RAMP REPORT REGION 2 ADA 2026

Lawerence St., & Ingraham Lane,
Rockland

CR04132

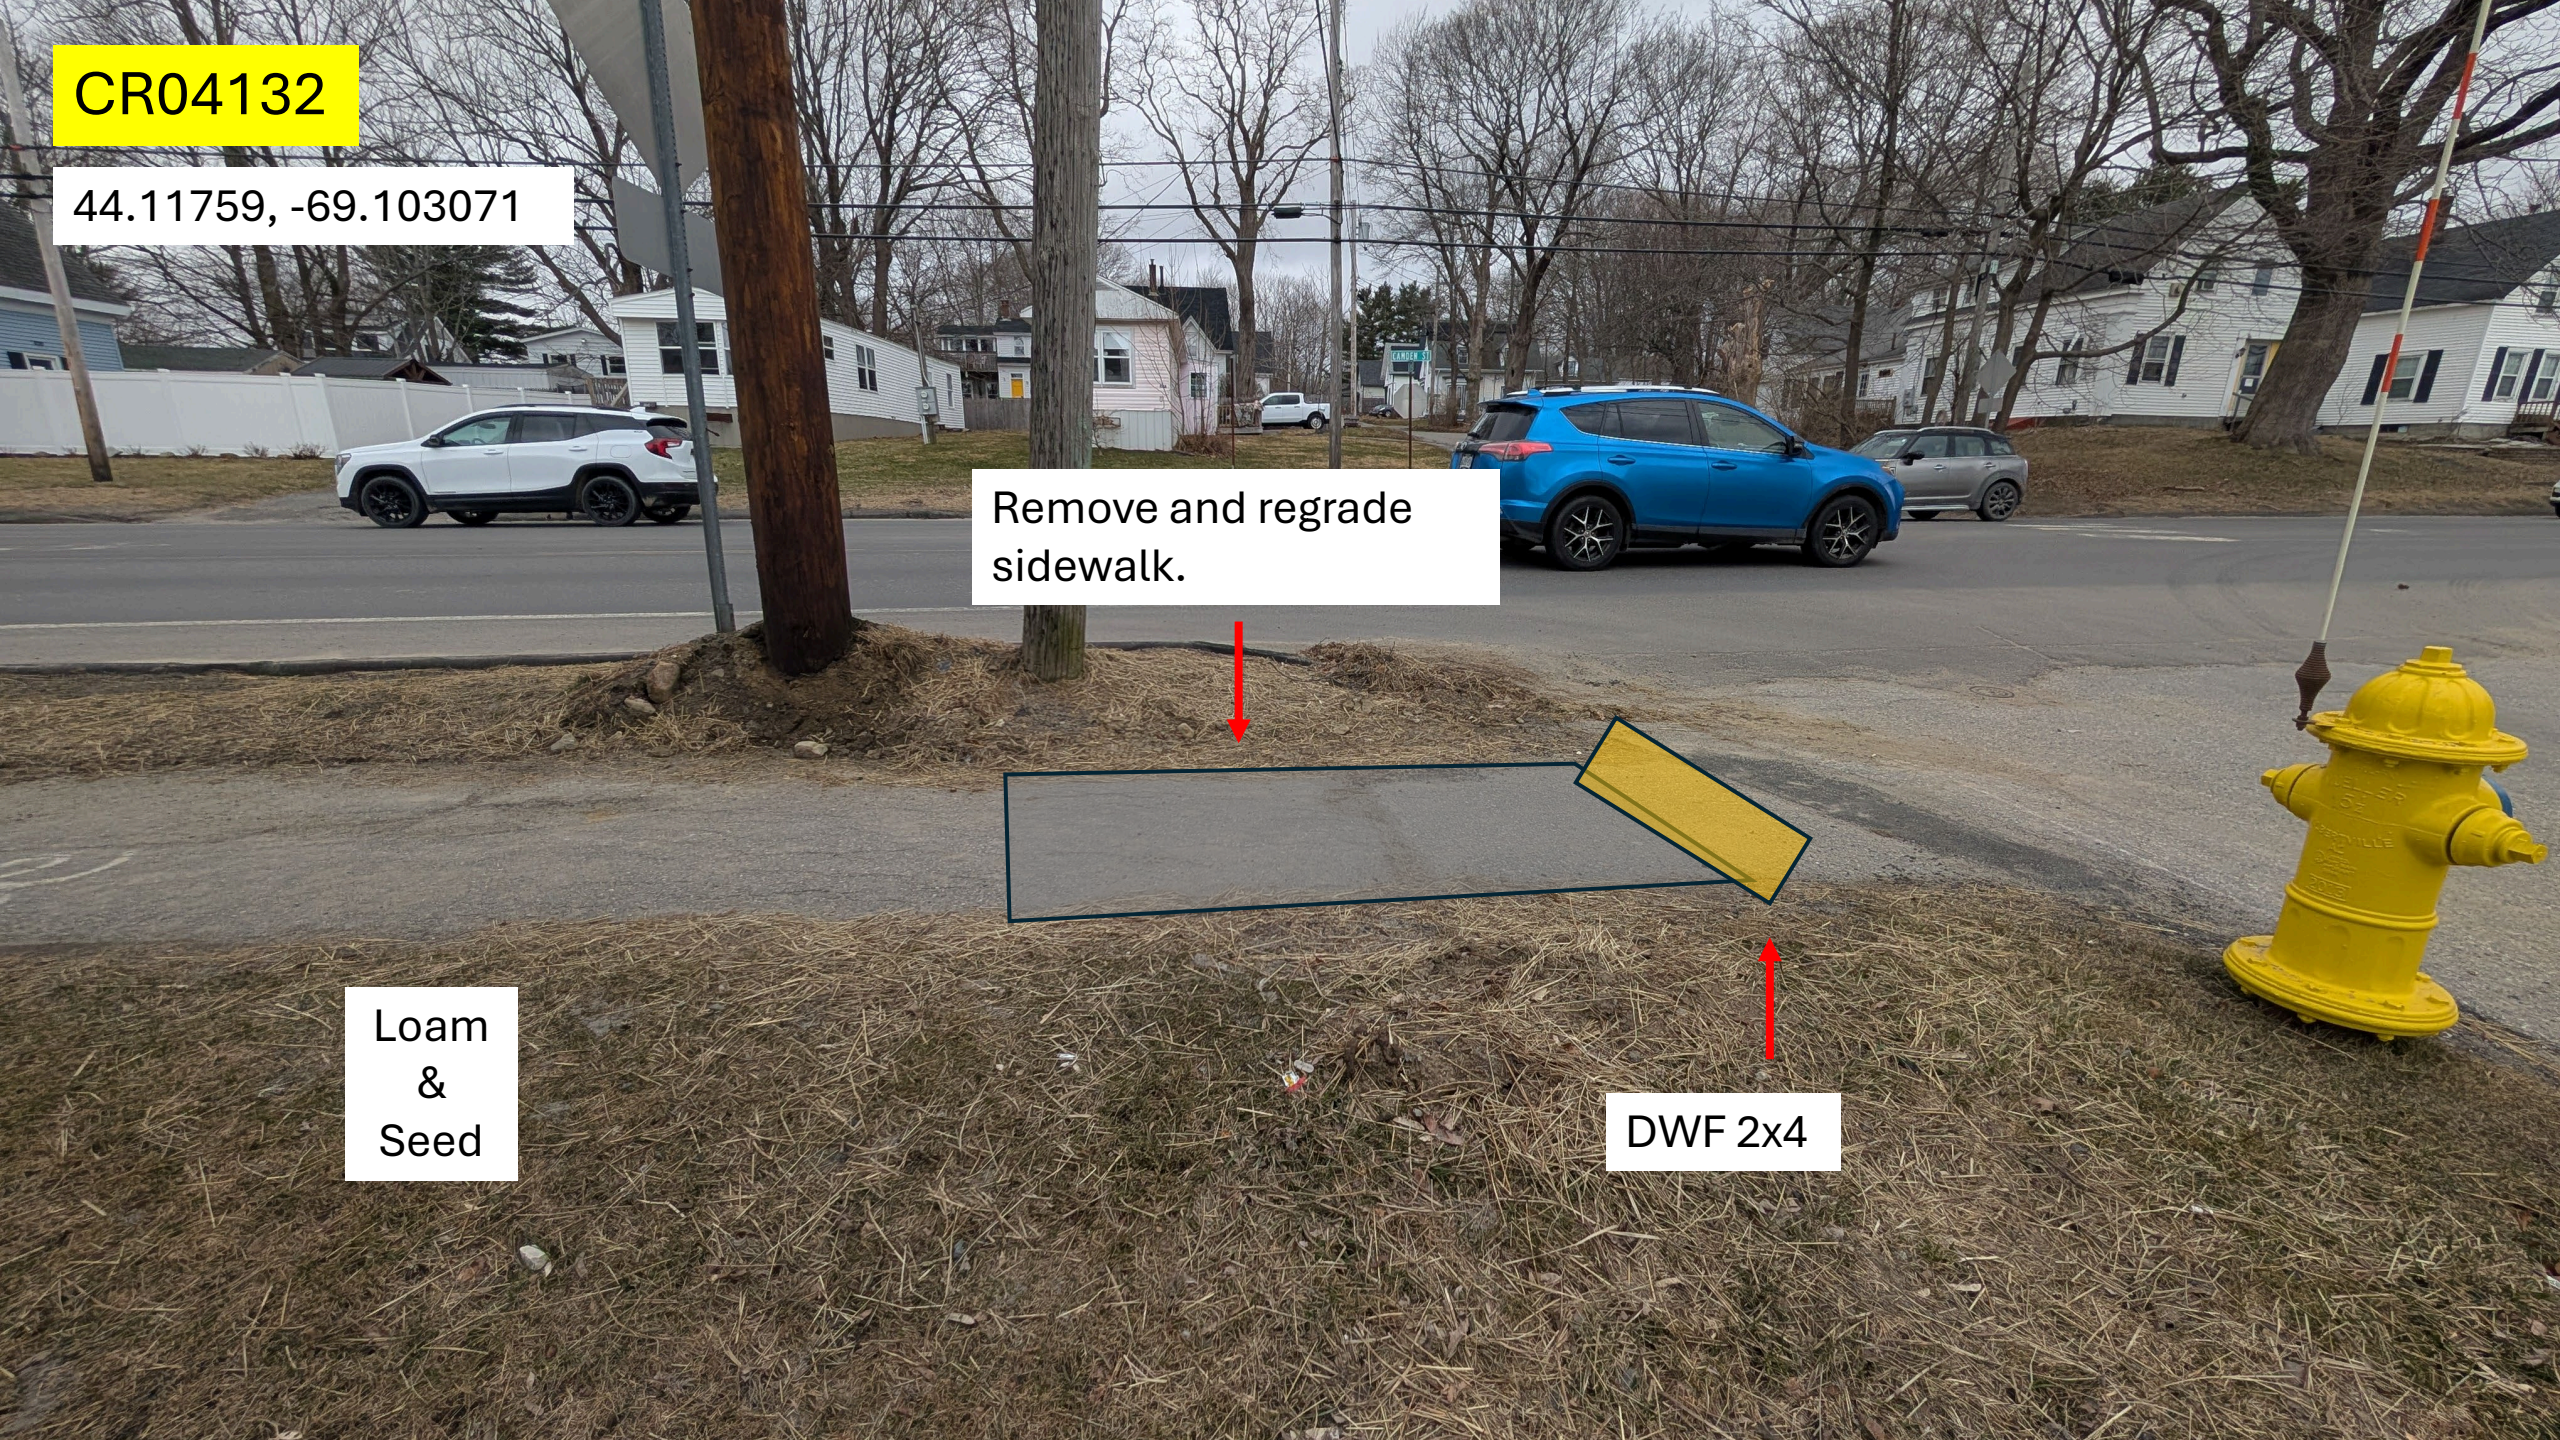
Remove and regrade sidewalk.

Loam
&
Seed

DWF 2x4

CR04130

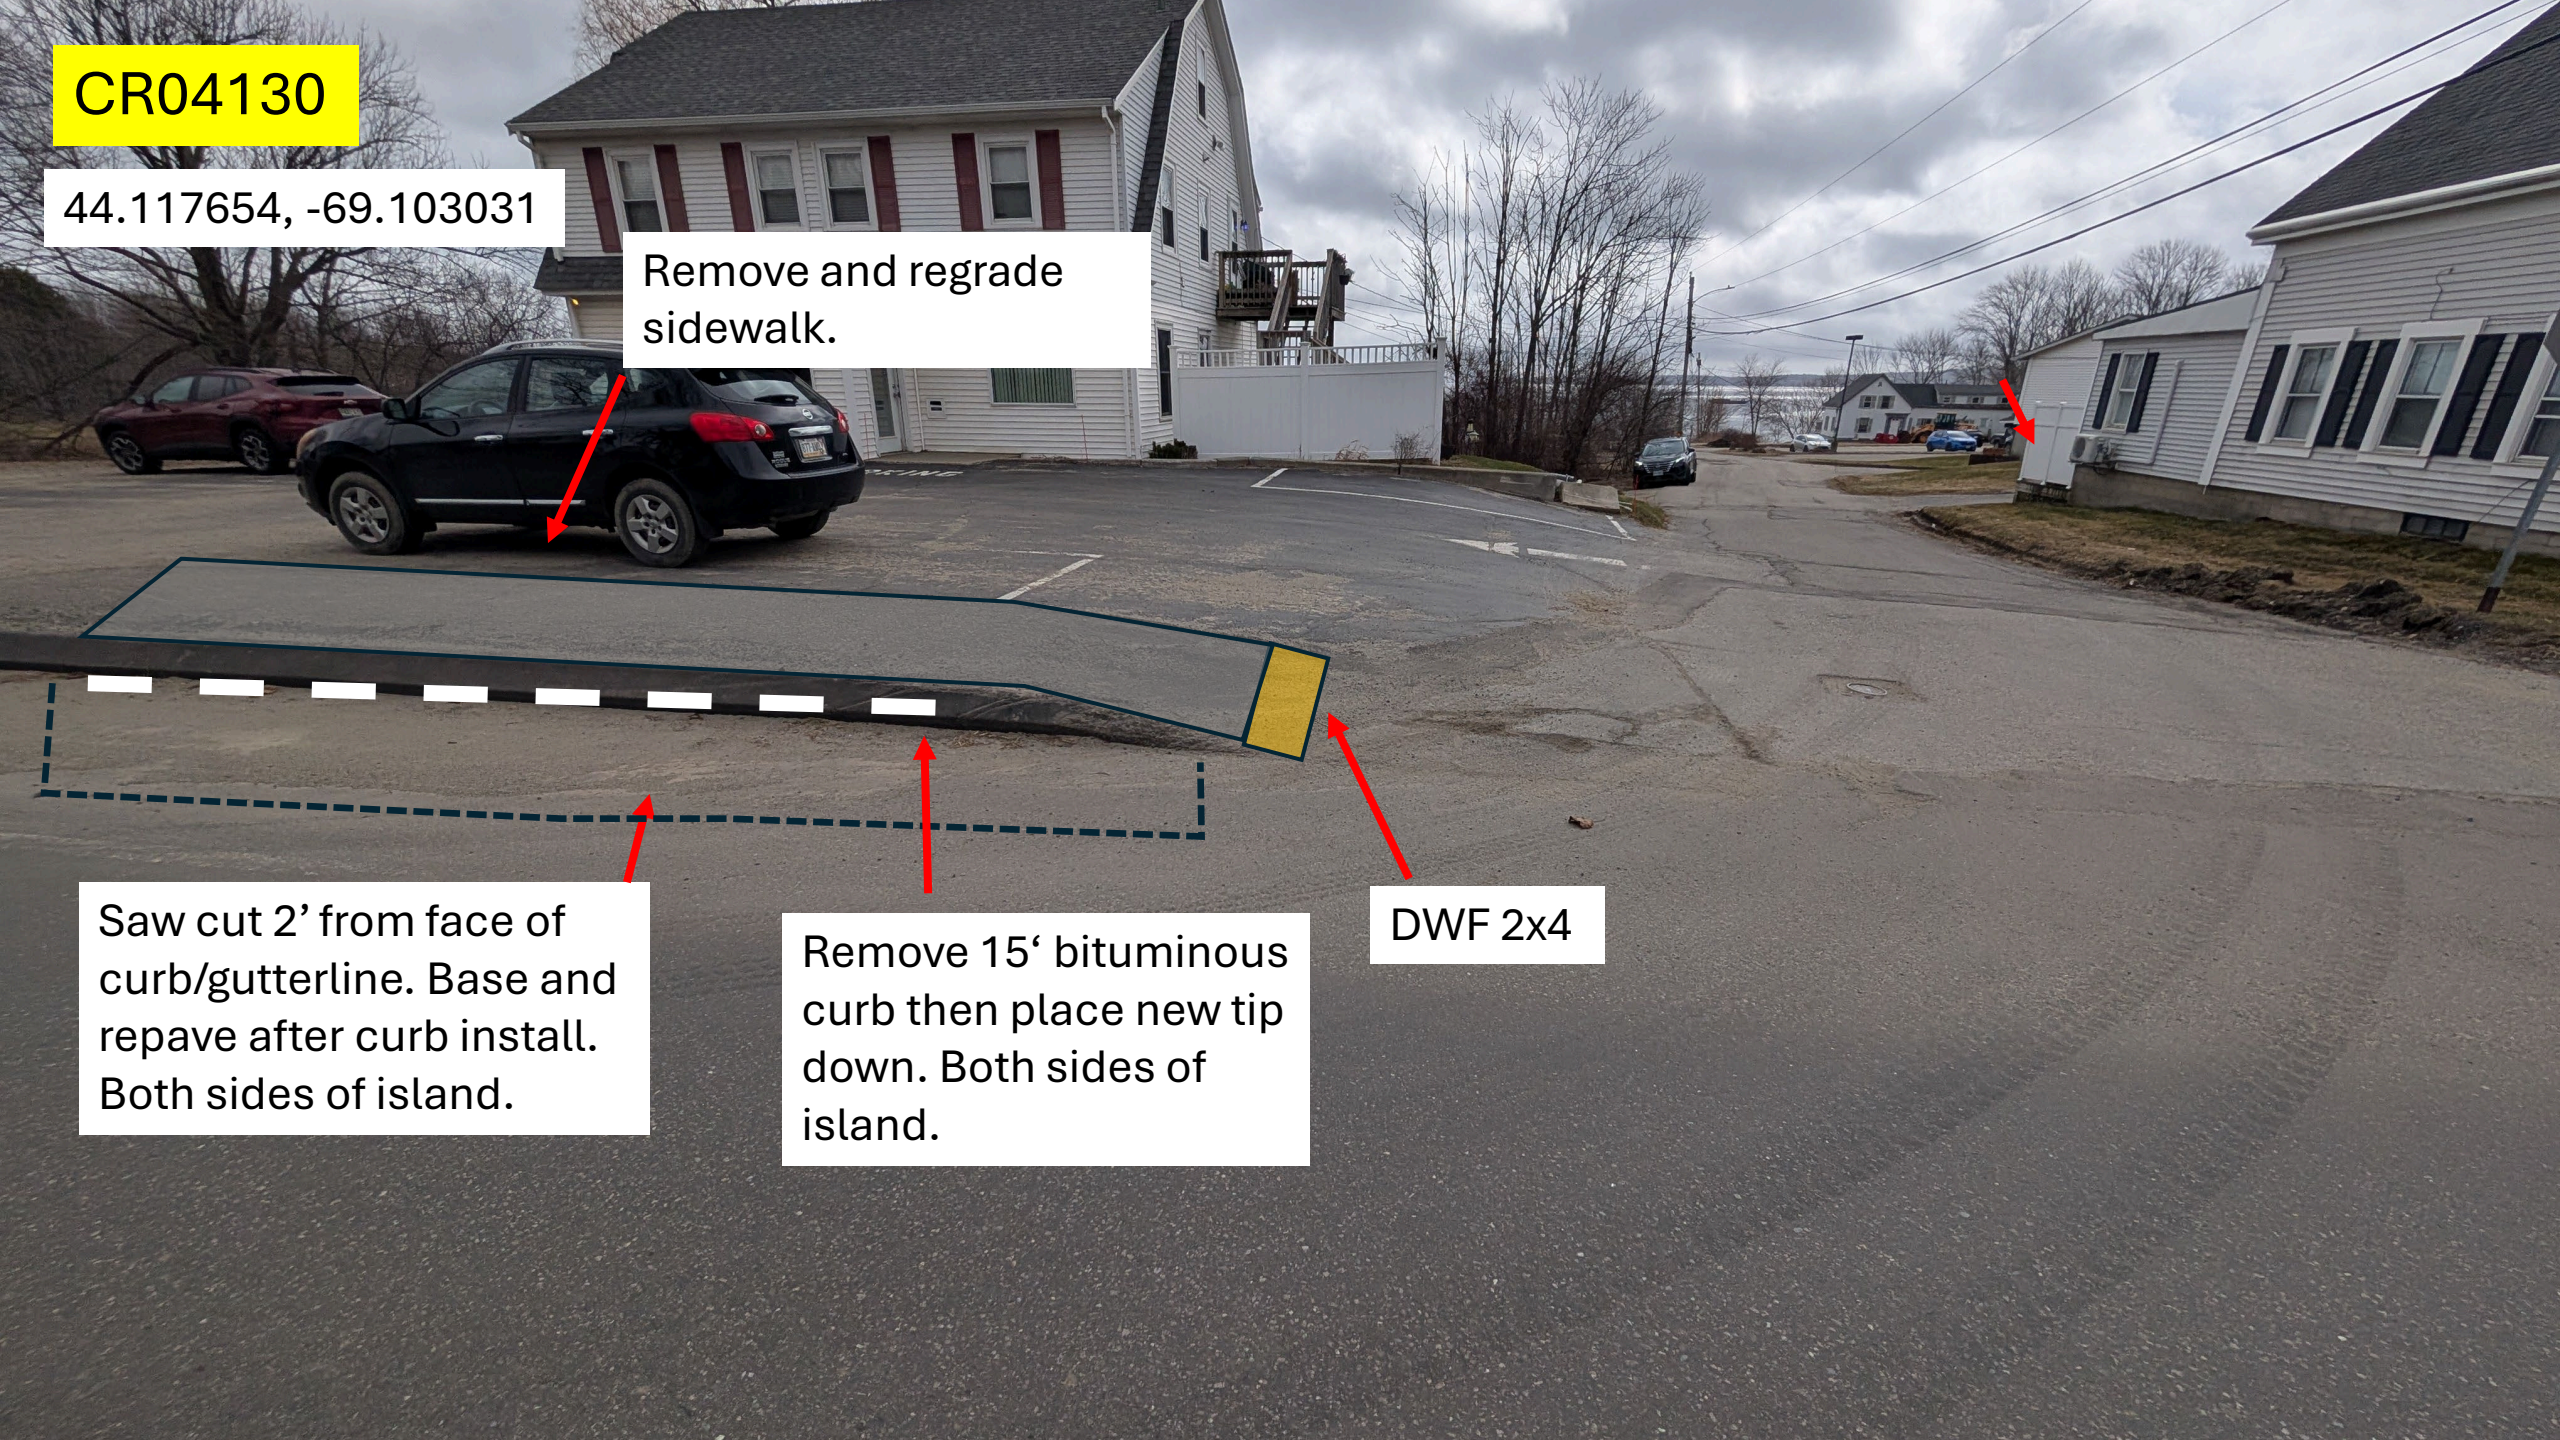
Remove and regrade
sidewalk.

Saw cut 2' from face of
curb/gutterline. Base and
repave after curb install.
Both sides of island.

Remove 15' bituminous
curb then place new tip
down. Both sides of
island.

DWF 2x4

CR04131

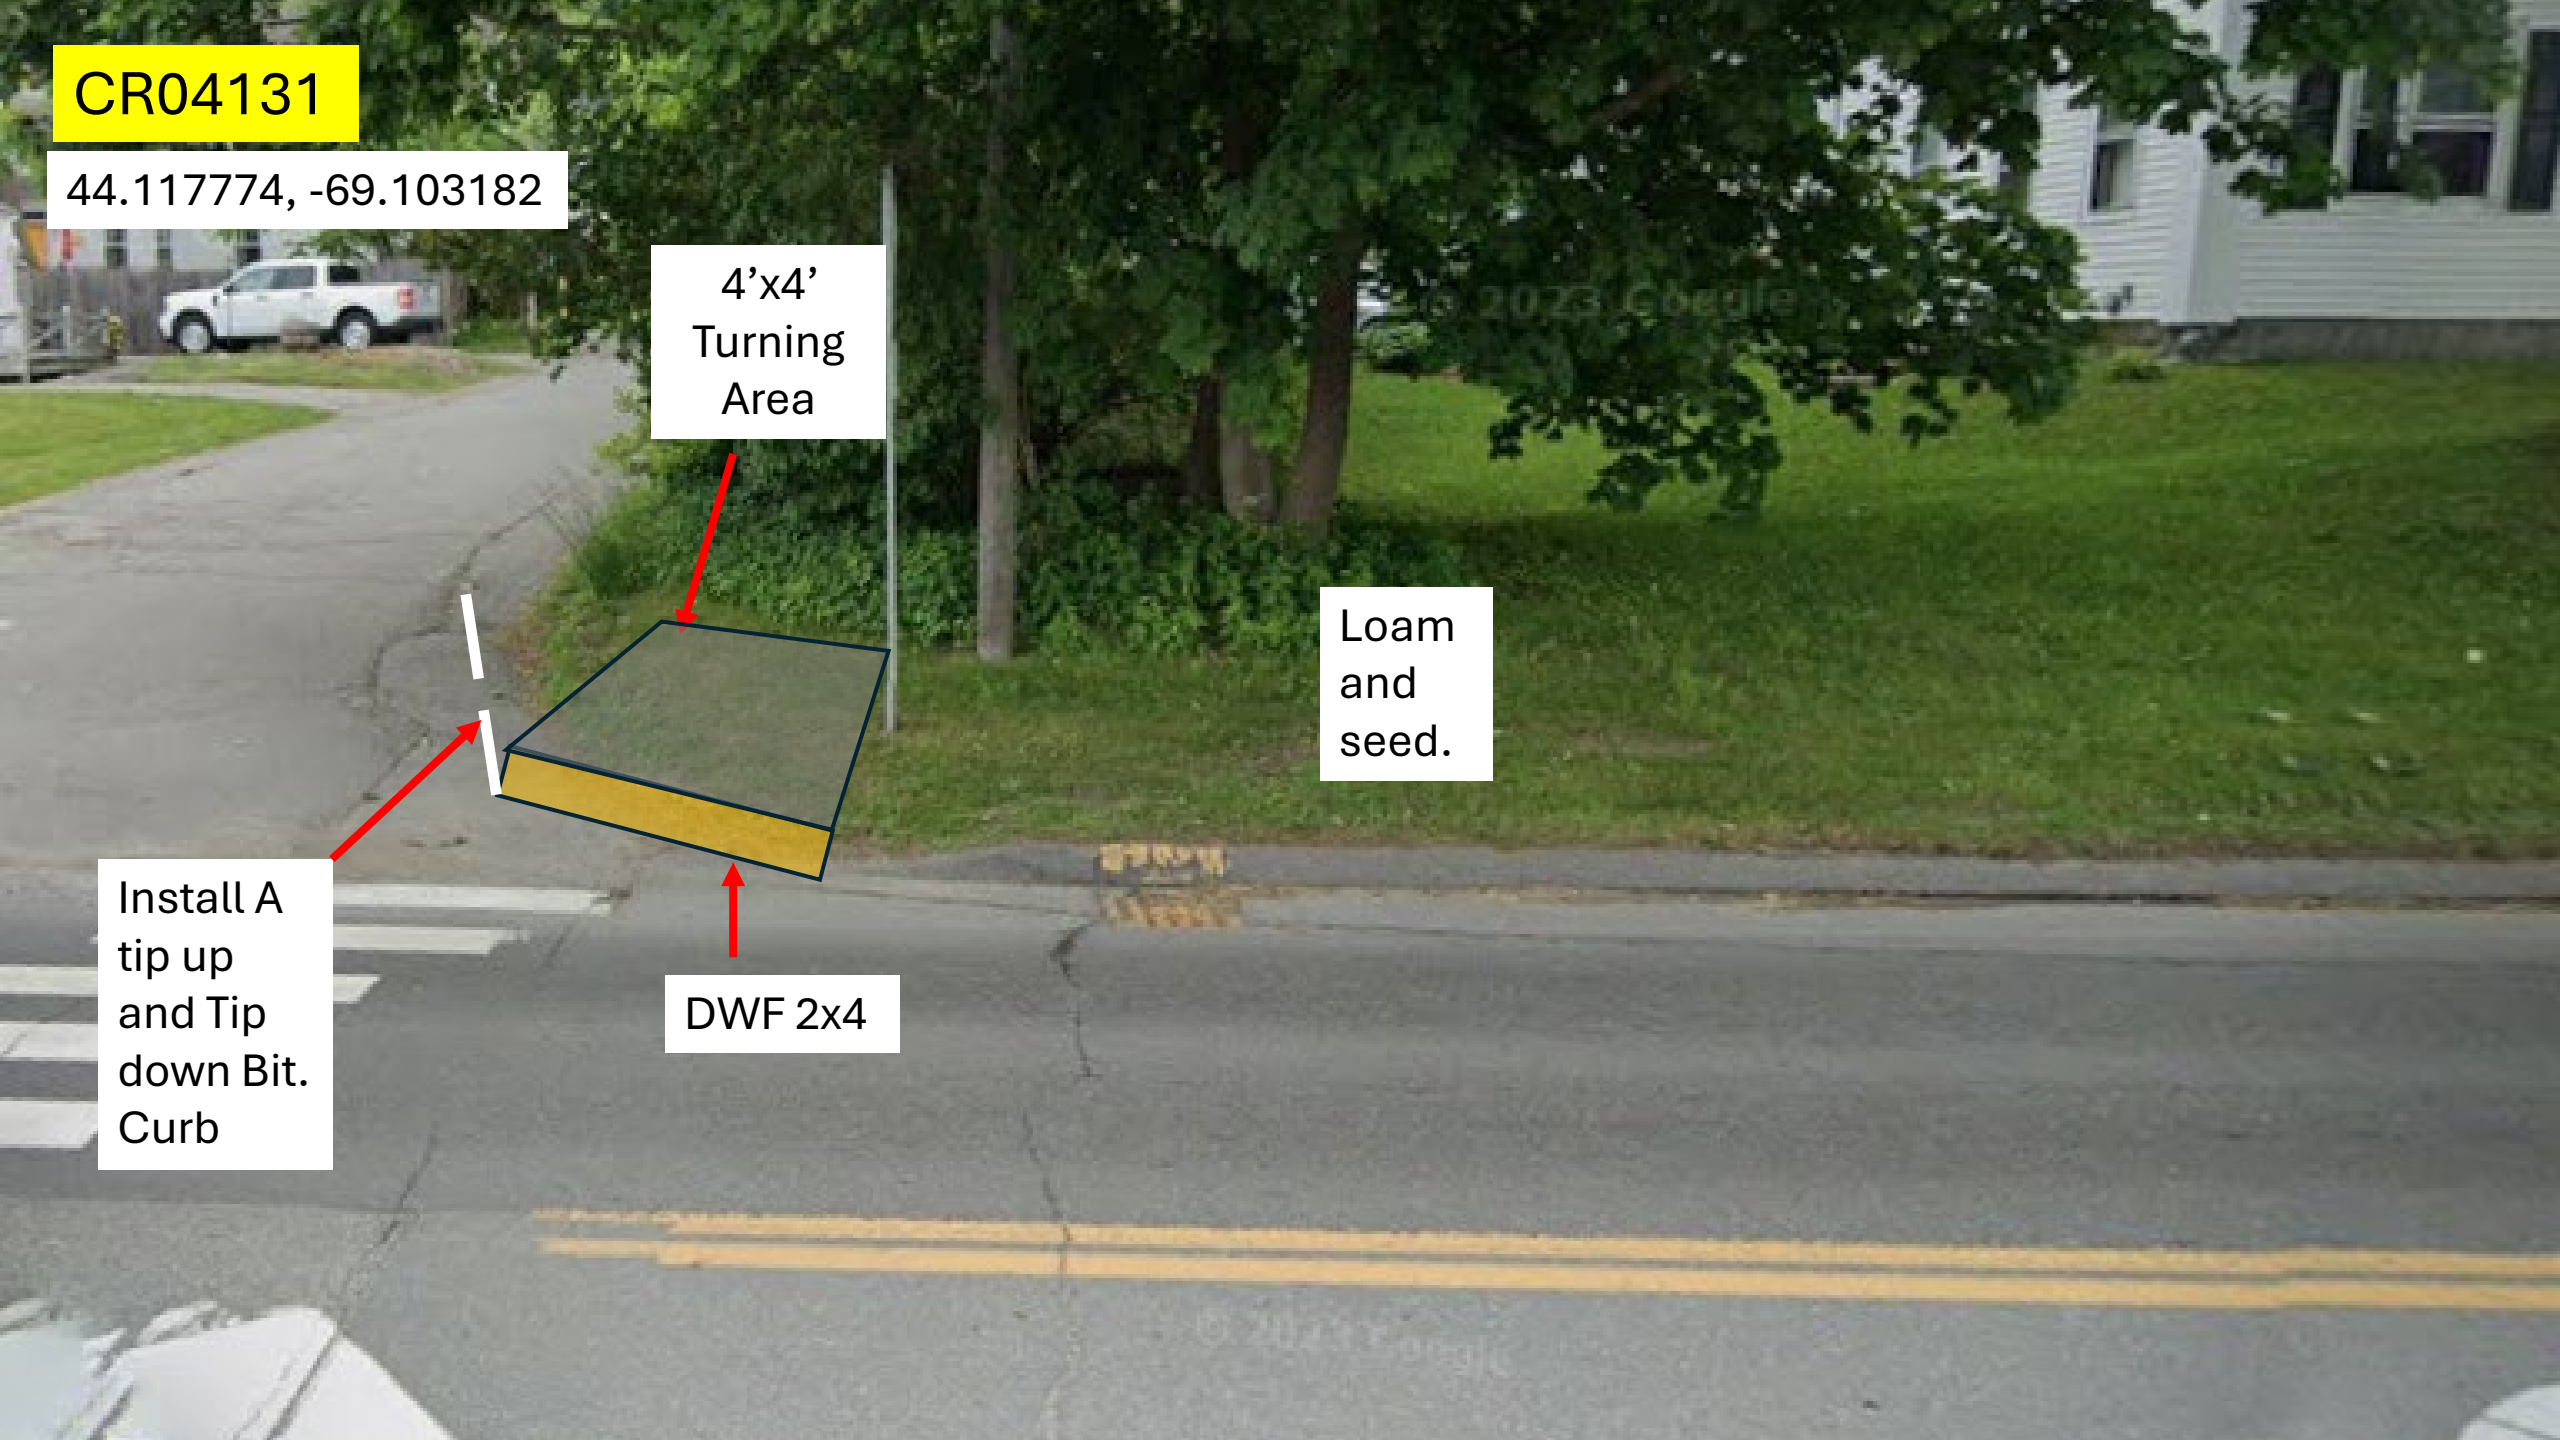
4'x4'
Turning
Area

Loam
and
seed.

Install A
tip up
and Tip
down Bit.
Curb

DWF 2x4
